APPLICANT'S IMPERVIOUS COVER CALCULATIONS FROM 23 MAR 2018 CONSTRUCTION DRAWINGS

APPLICANT'S IMPERVIOUS COVER CALCULATIONS FROM 15 MAY 2018 CONSTRUCTION DRAWINGS

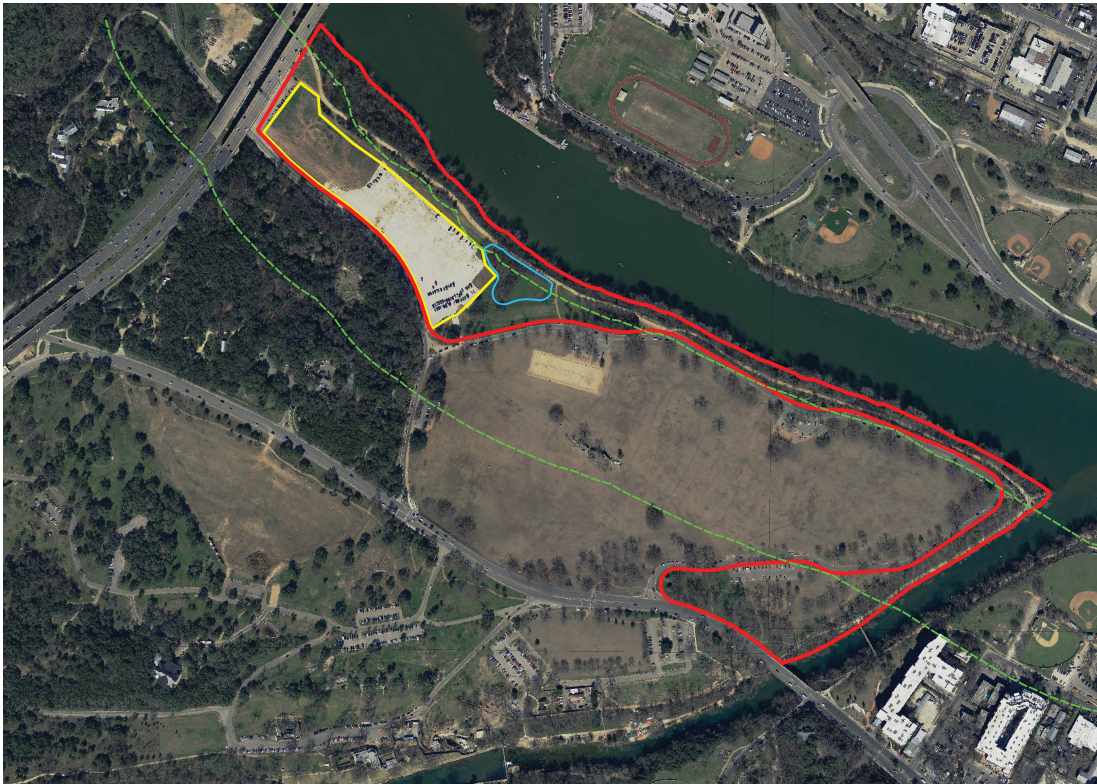
In the 23 Mar 2018 Site Plan submittal, the applicant appropriately based the total tract area on the TCAD tract and City lot upon which the proposed parking lot sits. However, the applicant incorrectly used the total tract area instead of the secondary setback area within the total tract area to calculate the proposed percent impervious cover for the secondary setback area. Instead of the 26.14% that was calculated and shown in the table below, the actual proposed impervious cover in the secondary setback area is 7.96 ac divided by 17.93 acres, or 44.4%. This is over the 30% impervious cover allowed in the secondary setback area.

The red line in the aerial photo above is the boundary of the total tract area (30.45 acres) used in the table below. It consists of one TCAD tract (PID #105461). This tract is the same as the lot shown on the City of Austin Property Profile Report and Zoning Profile Report. The dashed green lines are the primary and secondary Waterfront Overlay setbacks.
